CAP Meeting Agenda

ITEM 4.1**DEVELOPMENT APPLICATION – 24018265 – 13 RALDON GROVE MYRTLE BANK**

DEVELOPMENT NO:	24018265
APPLICANT:	Peter Jones Ryan Horsnell
ADDRESS:	13 RALDON GR MYRTLE BANK SA 5064
NATURE OF DEVELOPMENT:	Alterations and additions to the existing dwelling, including partial demolition, the removal of two regulated trees and construction of a carport, verandah, deck and swimming pool and associated safety barriers.
ZONING INFORMATION:	<p>Zones:</p> <ul style="list-style-type: none"> • Established Neighbourhood <p>Overlays:</p> <ul style="list-style-type: none"> • Airport Building Heights (Regulated) • Affordable Housing • Historic Area • Prescribed Wells Area • Regulated and Significant Tree • Stormwater Management • Traffic Generating Development • Urban Tree Canopy <p>Technical Numeric Variations (TNVs):</p> <ul style="list-style-type: none"> • Maximum Building Height (Metres) (Maximum building height is 6m) • Minimum Frontage (Minimum frontage for a detached dwelling is 12.5m) • Minimum Site Area (Minimum site area for a detached dwelling is 400 sqm) • Maximum Building Height (Levels) (Maximum building height is 1 level) • Minimum Side Boundary Setback (Minimu

FIRST FLOOR PLAN -OVERLOOKING DIAGRAM

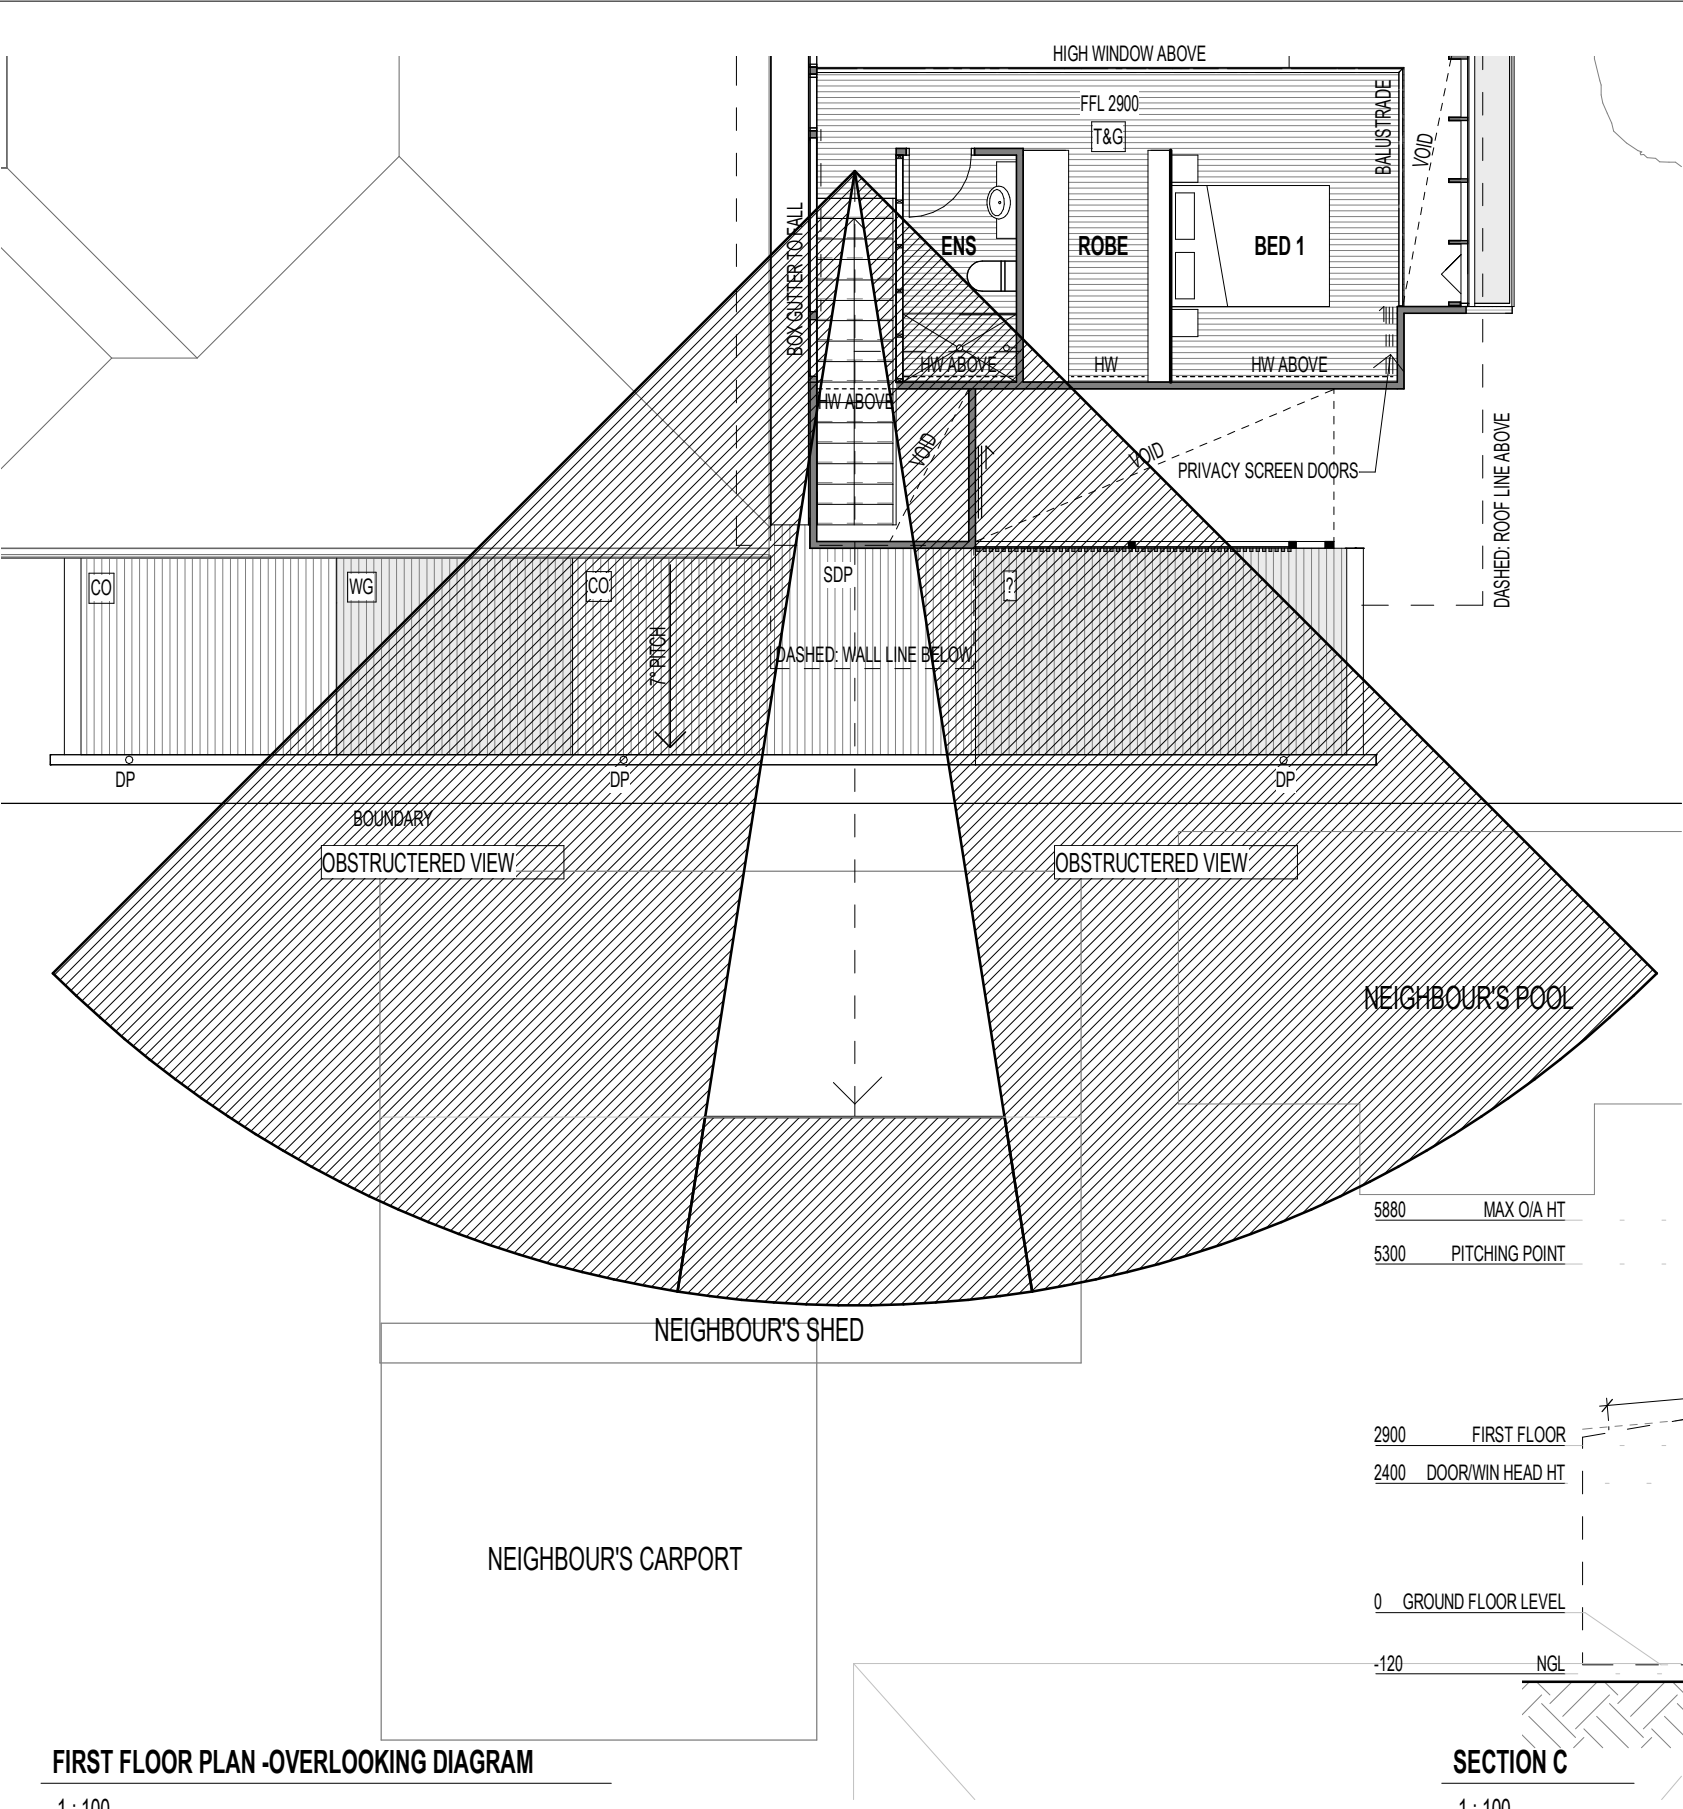
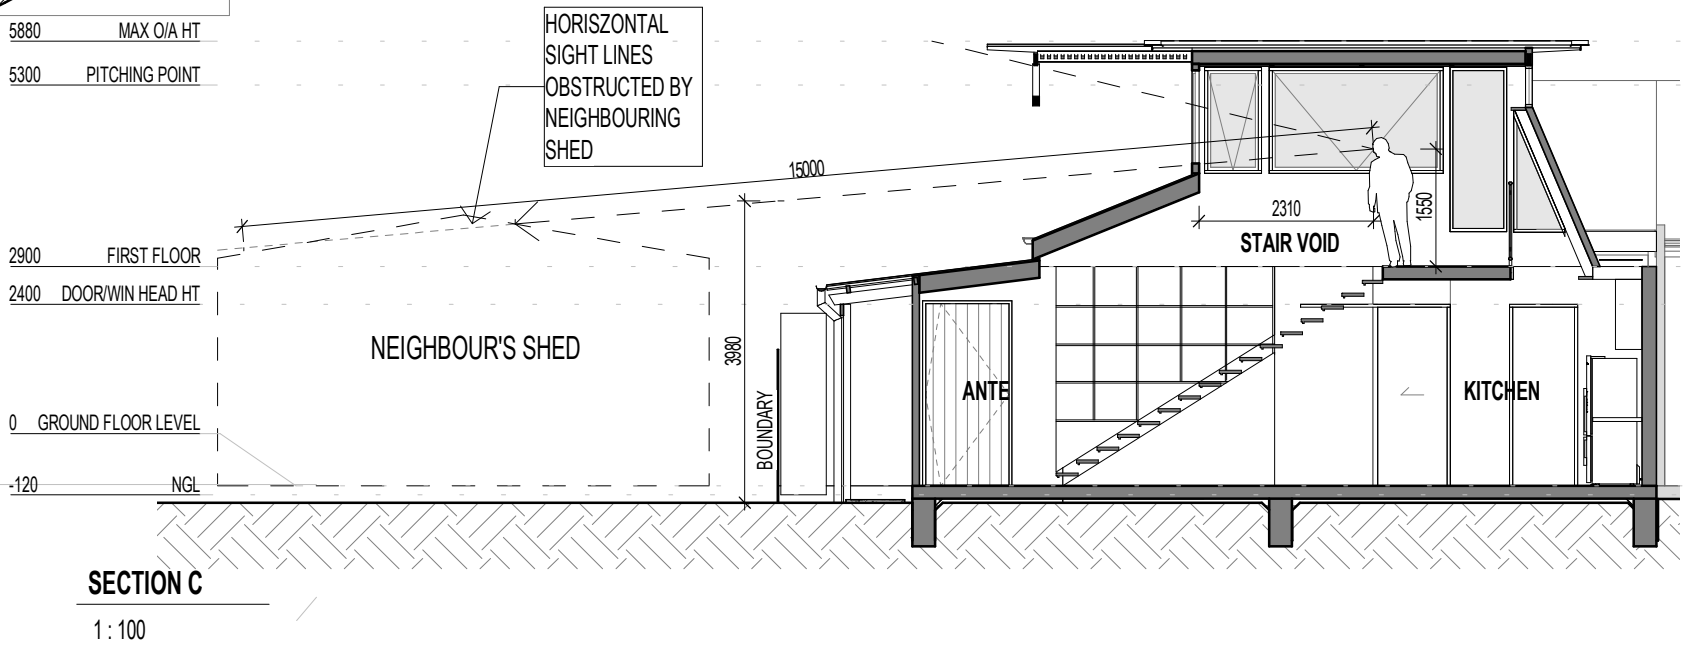
The applicant provided a response to the representations which can be found in **Attachment 3**. This response was provided to the representors. The only amendment made to the plans in response to the representations were increased privacy screening on the western elevation.

To address concerns regarding overlooking from the first-floor western windows, we have ensured that the sill height of these windows is 2.1m, which exceeds the minimum requirement of 1.5m above finished floor level as stipulated in **DTS/DPF10.1.B**. (please refer below high level windows highlighted yellow)

Item 2.1 Overlooking

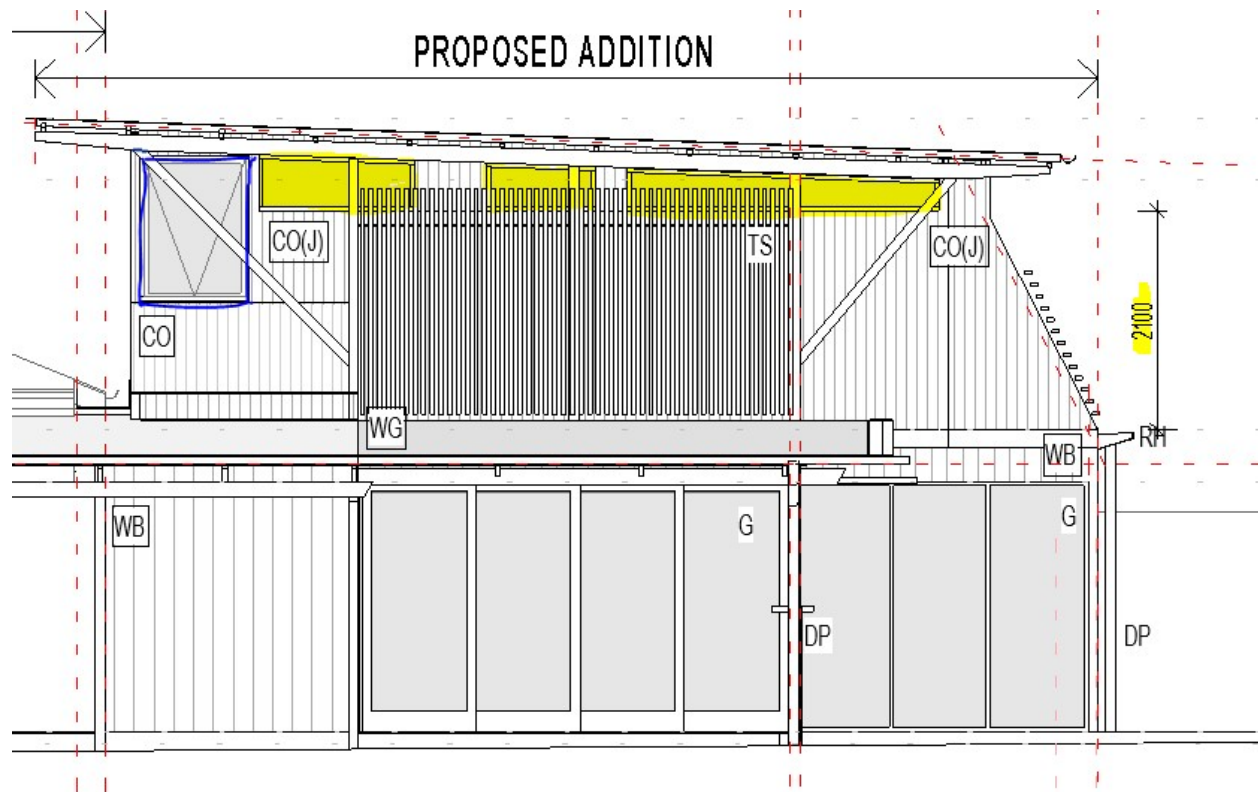
We appreciate the concerns raised by the owner of [REDACTED], particularly with regard to overlooking.

The only exception to this is the void stair window (highlighted blue above), which is located at a height that would require a person to be standing on the landing in order to view through it. Even then, the line of sight would be purely horizontal, and the view is further obstructed by the neighbouring shed roof, creating a natural barrier that prevents any direct line of sight into the neighbouring properties or areas. This view is further obstructed by the neighbouring shed roof. This fixed barrier effectively prevents any direct line of sight to neighbouring properties or areas.
